July 29, 2021

Product Change Notice - New supplier for hydraulic pressure switches

Current Nason Pressure Switch

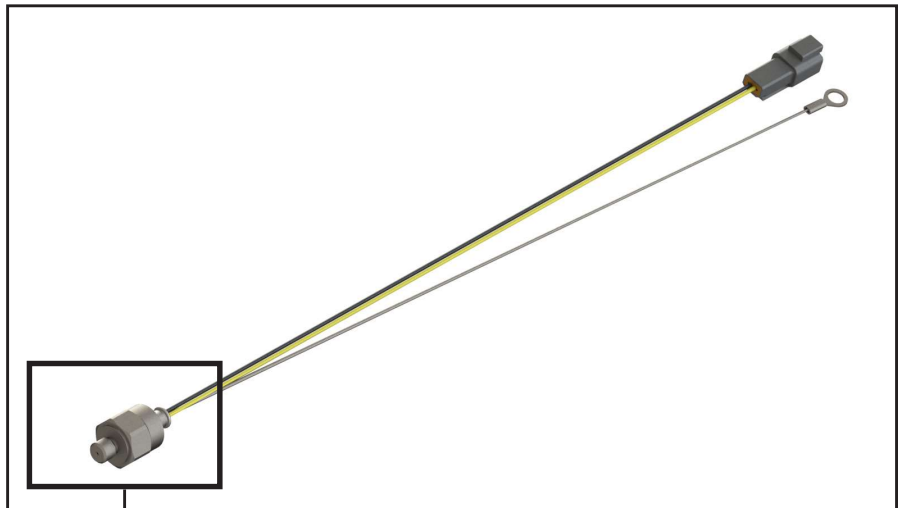
The current pressure switch (PN 142927) is a two-wire mechanical switch by Nason. The new supplier, Anfield, supplies a solid state, three-wire switch (2020109583). The third wire on the new switch must be connected to 12V power. That third wire will be wired by Lippert prior to shipment to the OEM customer.

A benefit to adding the solid-state Anfield switch is eliminating false alarms on "jack down" warning lights by lowering the falling pressure threshold to 500 psi.

There is no change in installation, operation or function with the new Anfield switch. There is no price change for the new pressure switch. The change will be made starting XXXX.

1. **Will a new part number be required?** Yes, PN 142927 will be replaced by PN 2020109583.
2. **Does the price change for the item?** No, the price will not change.
3. **Is the new part wholly interchangeable with the previous version of the part?** The switches are interchangeable, however the new switch has a third wire to be connected to a power source.
4. **Does the customer need to replace inventory?** No, the change will be made starting XXXX.
